Martin's Point Bridge : Responses to Additional Follow Up Questions Received on the Final Request for Proposals (Final RFP), January 31, 2012

Subject: Falmouth-Portland, Martin's Point Bridge Design-Build Project (MaineDOT PIN 16731.00) – Responses to Additional Follow Up Questions Received on the Final Request for Proposals (Final RFP)

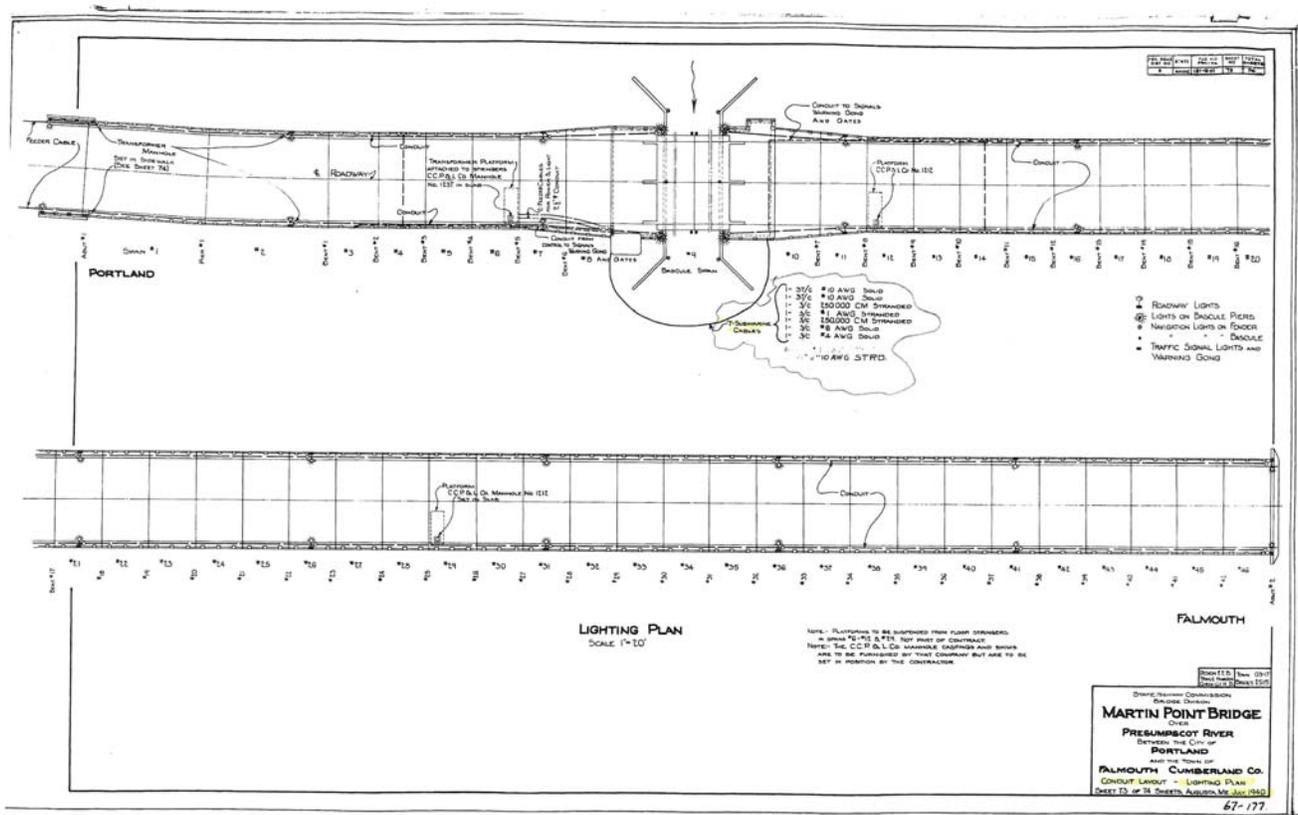
3. Referencing the attached drawings, please clarify the status of the "7-Submarine Cables" shown on sheet 73 of the Department's 1940 drawings (file # 67-177). Have these cables been de-energized but not yet removed?

A. The Department does not know the current status of the submarine cables. The existing 1984 plans for the rehabilitation of the bridge do not indicate that the submarine cables were removed. Design-Builders can assume that the cables have been de-energized, but not removed, for the purposes of developing Technical and Price Proposals.
